Eye on Evanston: Thoughts on Design | Design Evanston reviews 2206 Maple Ave. apartment building

by David Galloway, Design Evanston and Jack Weiss, Design Evanston March 1st, 2025

Professional members of Design Evanston met with the developer Paul Harb and architect Gregory Geslicki on January 23 to review the proposed multifamily apartment building at 2206 Maple Ave.

Ground floor plan at 2205 Maple Ave. Credit: Gregory Geslicki

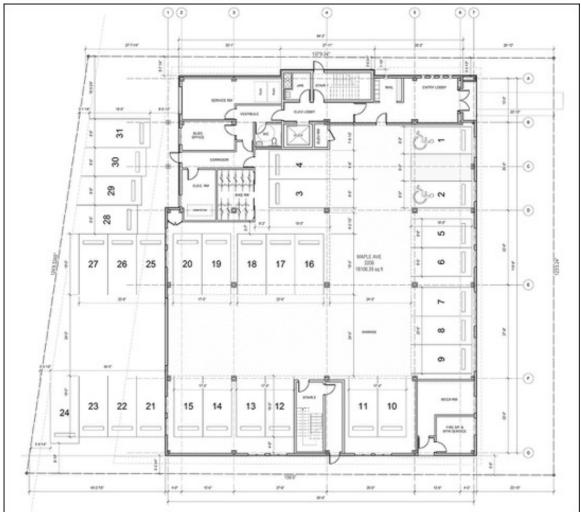
Currently, interior vehicle parking spaces are arranged behind the front first-floor elevation. If these spaces could be utilized for common tenant use or various beneficial amenities and made visually apparent from the outside, it would improve the facade's appearance from the pedestrian way and be more of an inviting and engaging experience and opportunity for passersby.

If some of the interior parking spaces at the front of the building were eliminated, as mentioned in Item 7 above, the freed-up space could be replaced with a variety of building amenities, such as a larger lobby, lounge area, conference/multi-purpose room, fitness room and additional bicycle storage (which we highly recommend), and result in an improved facade expression at the first floor. We understand, subsequent to our review, that the team has eliminated three interior parking spaces.

Rendering of west facade at 2205 Maple Ave. Credit: Gregory Geslicki

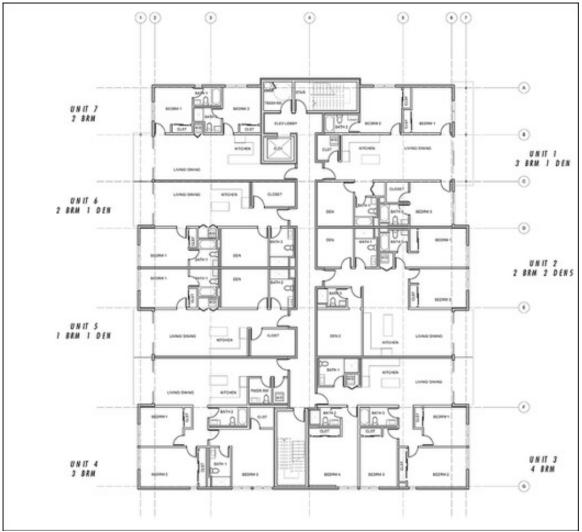
The front elevation of the building is its most prominent and important visual expression. We understand the front elevation is still under investigation and development. The current front elevation is a mix of traditional wide, vertical brick piers or wall planes and more contemporary horizontal balcony expressions with steel framing, all atop a relatively low height first floor contrasting masonry podium with different fenestration than the floors above. These three expressions, we believe, create a rather confusing composition that lacks coherence and intention that we believe is desired. We understand the project team is investigating some modifications to the facade expression.

The entry to the building is not as visually prominent as it could be.

Painted metal flashings, cornices, steel framing and perforated metal railing panels add complexity to the facade expression. Metal balcony railing assemblies should be durable and best obscure tenants' balcony furniture, etc., from view.

If, as indicated in the review session, the building is to have rain screen facades, the projection of slabs out on past the building wall on the front side of the building will be very difficult to drain. A change to a different slab arrangement on the front of the building should be considered so the rain screen will not be interrupted there. Additionally, the slab projected through the front wall will create conductive transfer of cold and heat under the exterior wall into the units on the front of the building.
